WASHINGTON PUBLIC POWER SUPPLY SYSTEM

MAY 1981

WNP-2

Replaces FSAR Figure 4.6-6a

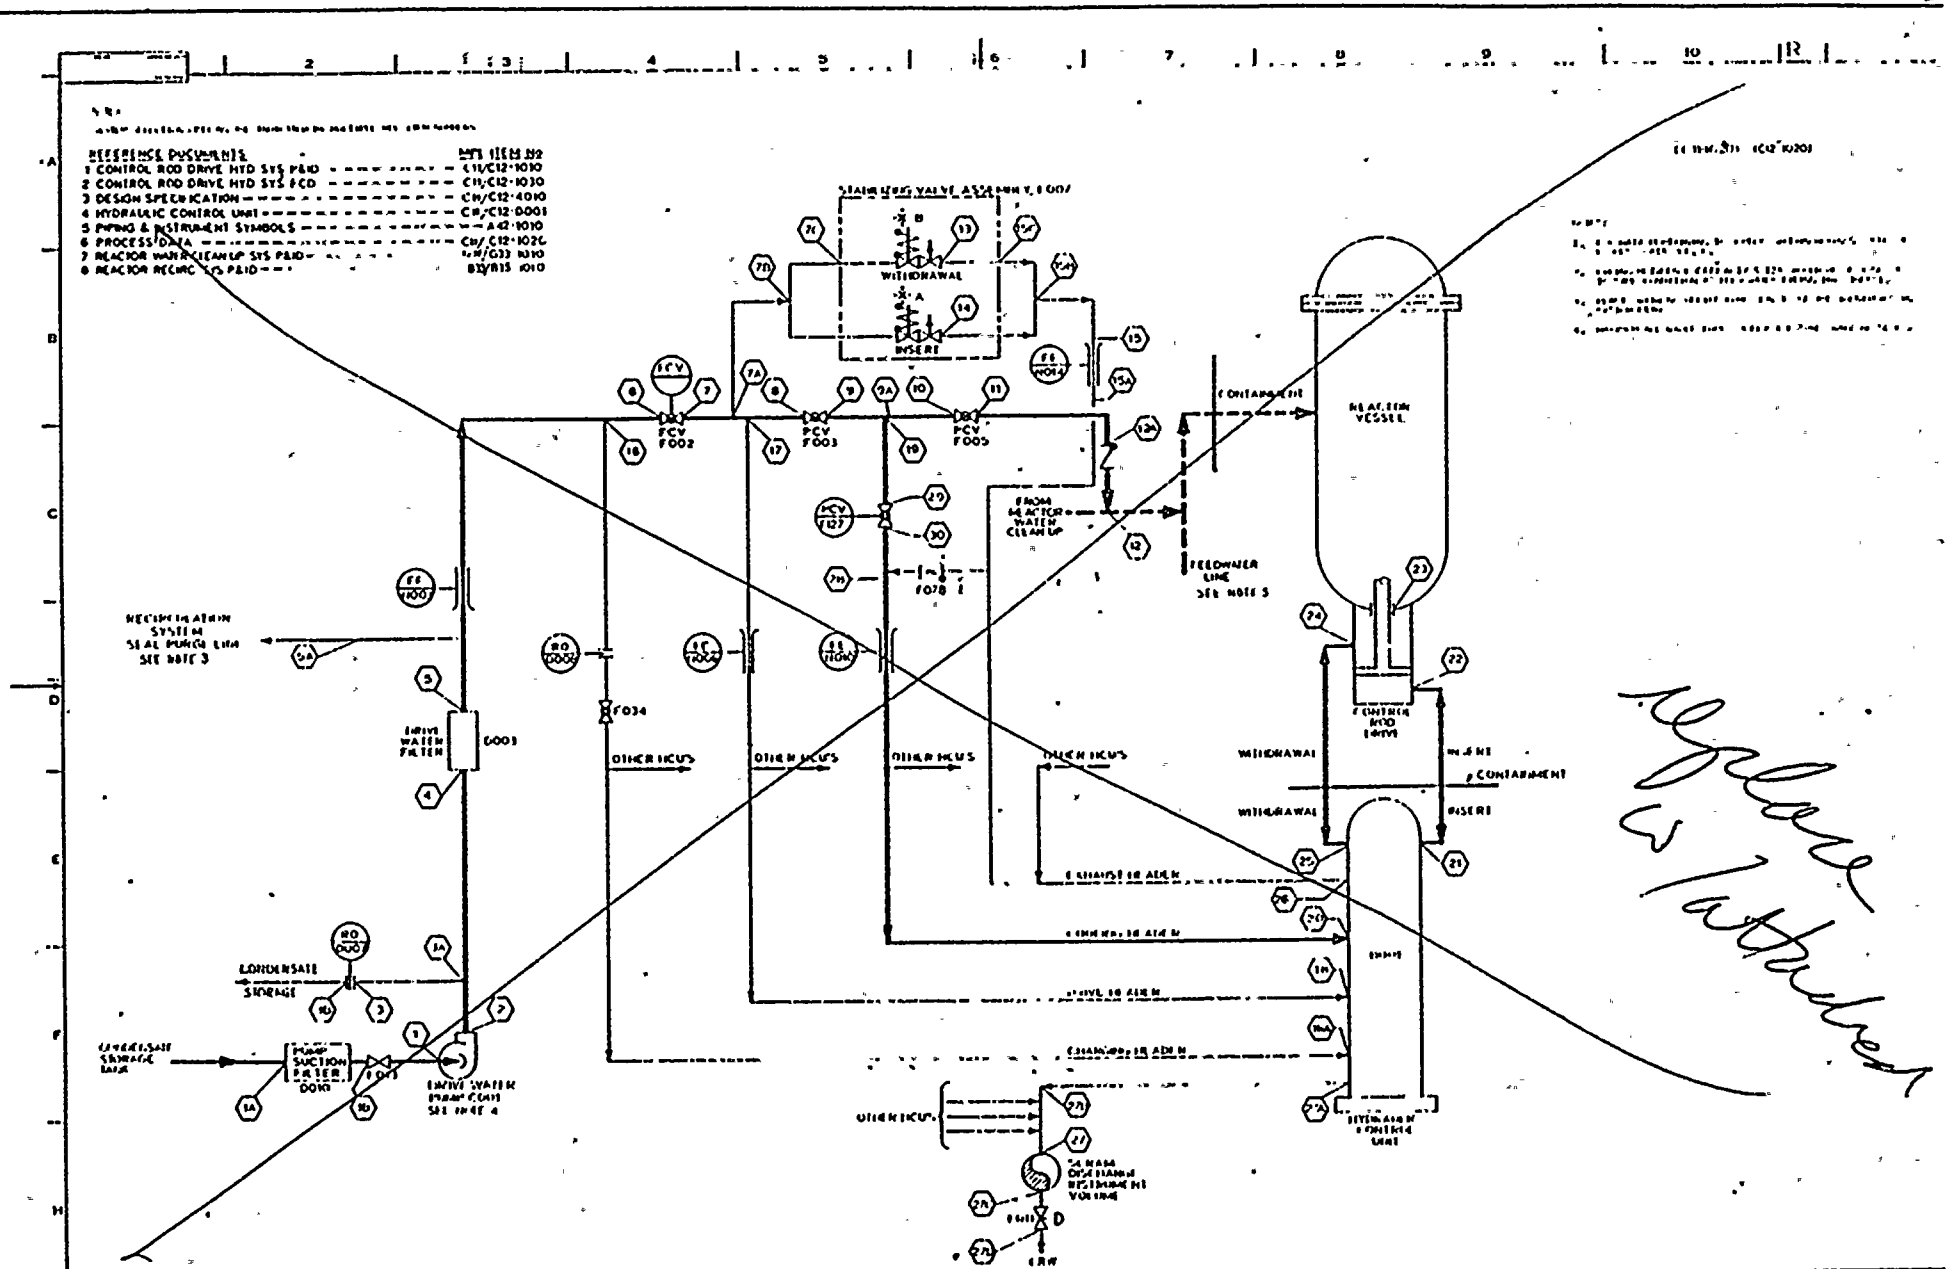
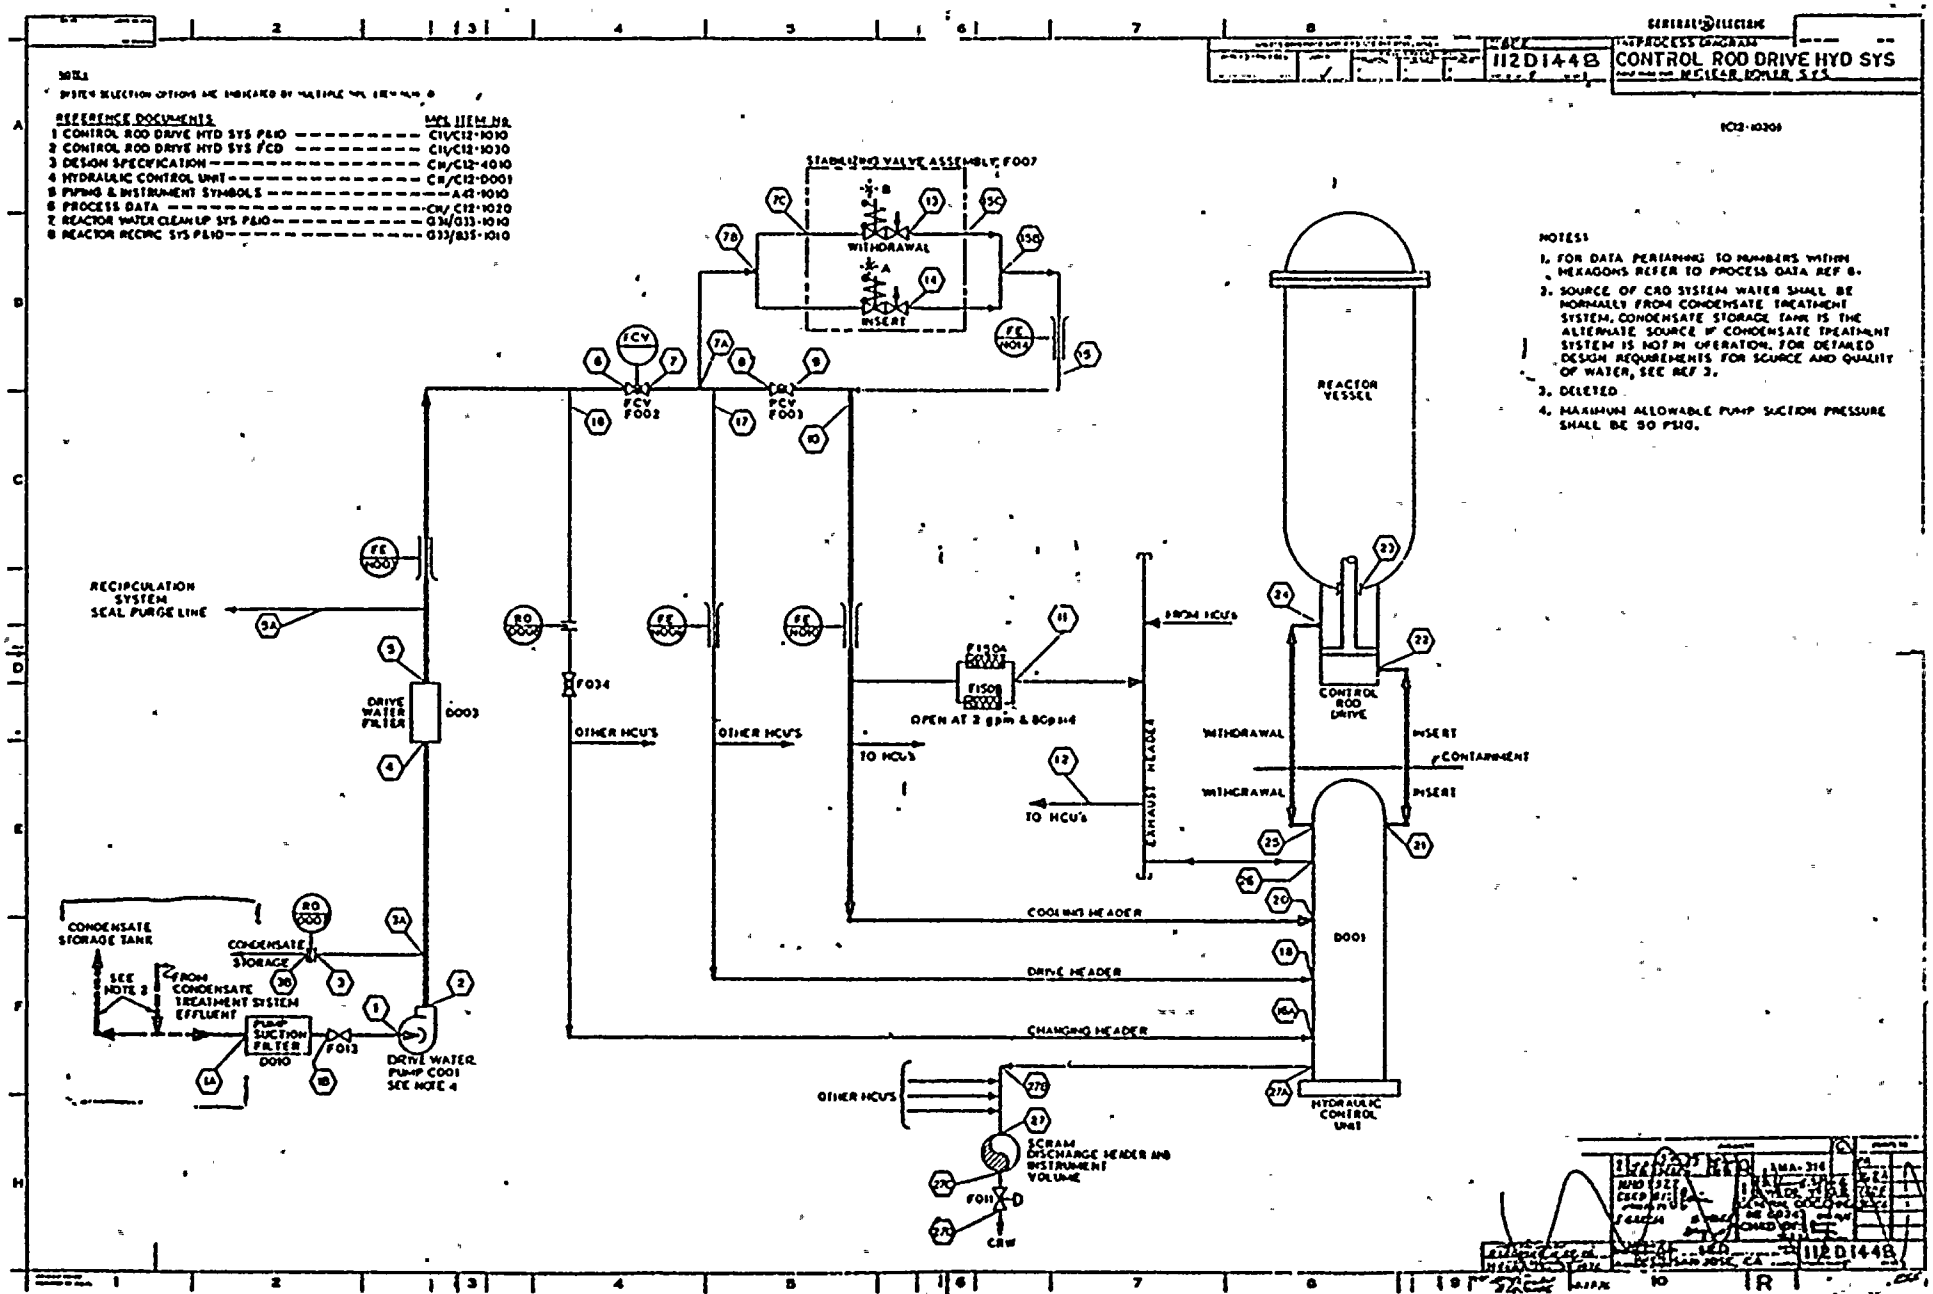
Table 1.3-8 indicates specific design changes from the PSAR to the FSAR for the CRD system. The design changes for the CRD return line modification addressed in Question 211.019, have not been included in the text description of the FSAR and Figures 4.6-5a, 4.6-5b, and 4.6-6a have not been revised. Revise the text description in the FSAR to reflect the specific design changes in Table 1.3-8 for the CRD system and modify the above figures accordingly.

Figures 4.6-5a, 4.6-5b, 4.6-6a, 4.6-6b, and 4.6-6c are revised to reflect the CRD return line modification. Figures 4.6-6d and 4.6-6e are deleted. Also, text sections 4.6.1.1.2.4, 4.6.1.1.2.4.1, 4.6.1.1.2.4.2.3, 4.6.1.1.2.4.2.4 and 4.6.2.3.2.2.8 are revised accordingly. Text section 4.6.1.1.2.4.2.5 is deleted.*

WASHINGTON PUBLIC POWER SUPPLY SYSTEM NUCLEAR PROJECT NO. 2	DETERMINATION OF BREAK LOCATIONS WHEN USING STRESS CRITERIA	FIGURE Q3-1

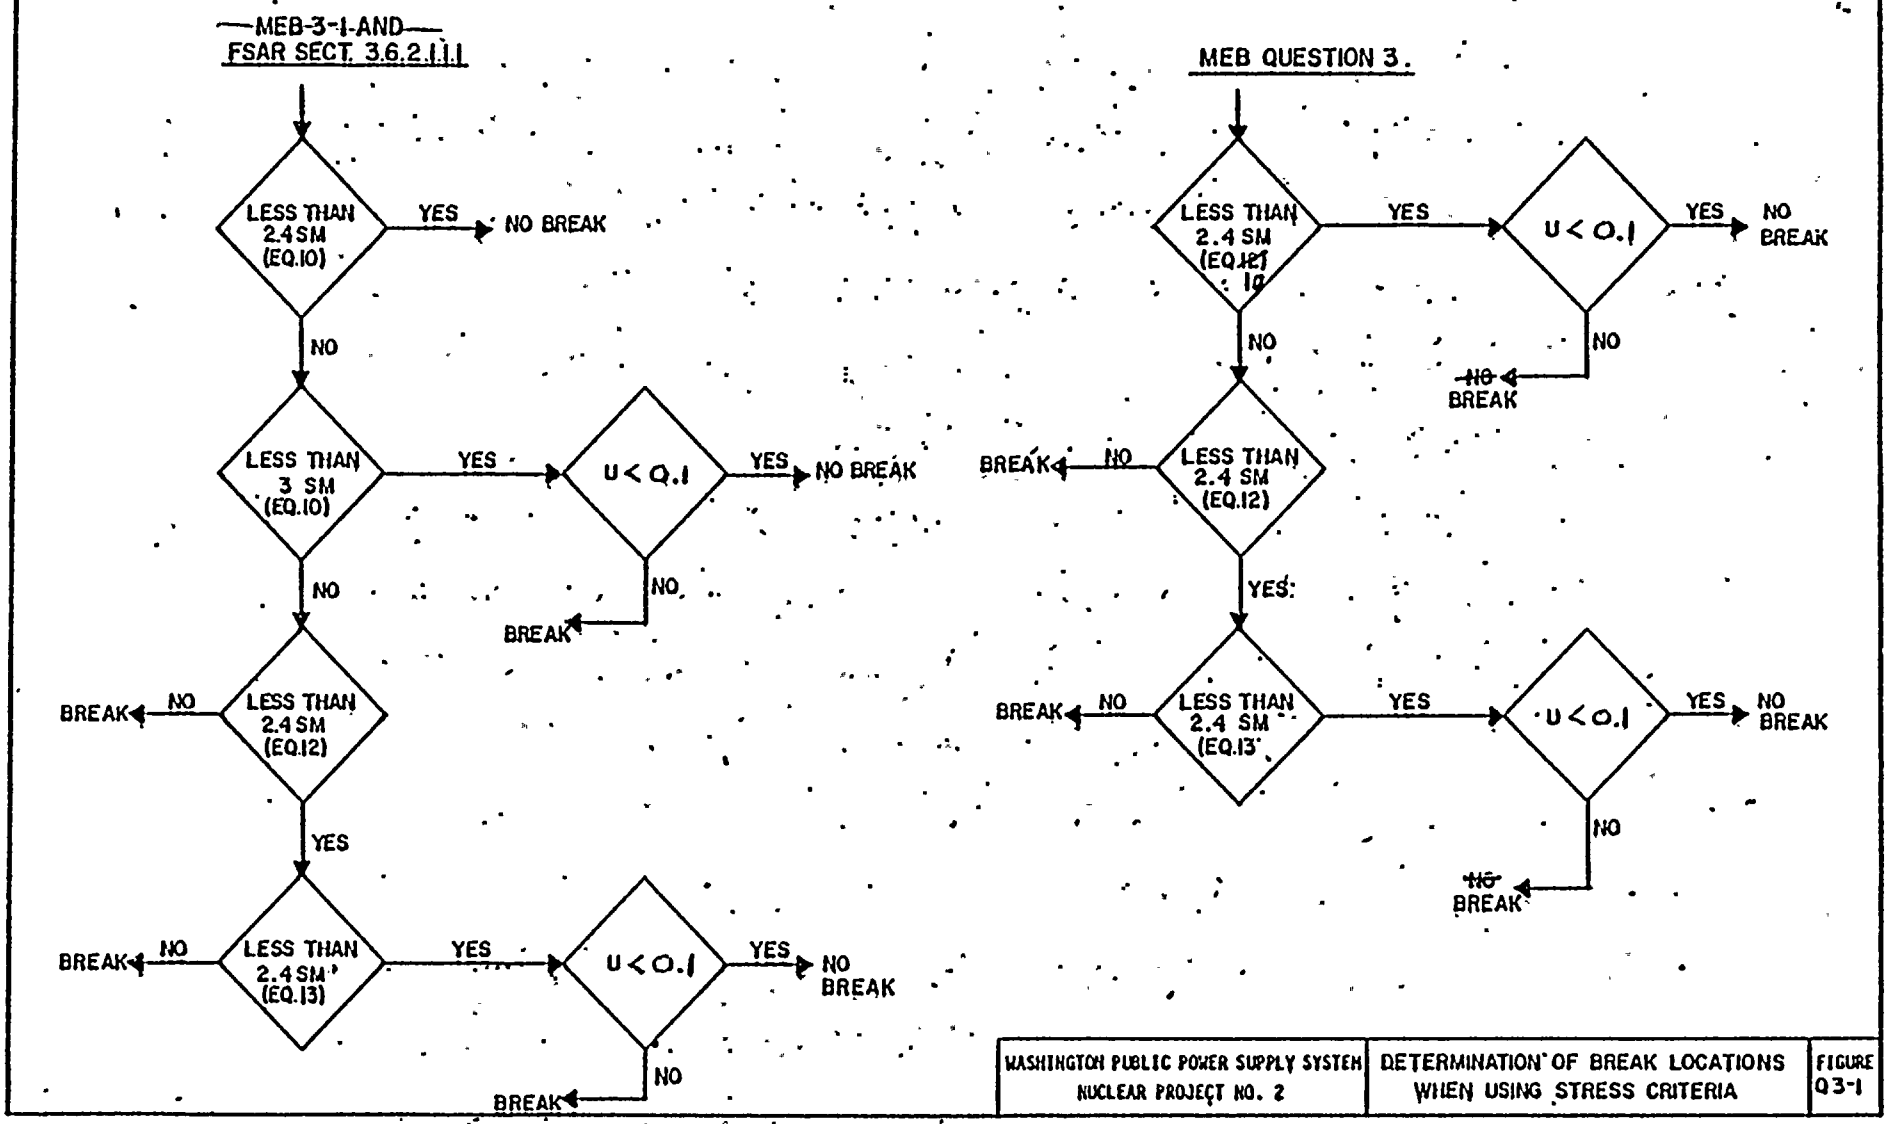
In order for us to complete our review, the applicant should provide a summary of the data developed to select postulated break locations including, for each point, the calculated stress intensity, the calculated cumulative usage factor, and the calculated primary plus secondary stress range. This data is required for review to ensure that the pipe break criteria have been properly implemented. Figures 3.6-11 through 3.6-36 are not completed.

Summation - In connection with the additional studies discussed in paragraph 3 of the response, the results of these studies will be supplied in the FSAR together with specific stress criteria to complete Figures 3.6-11 through 3.6-36.
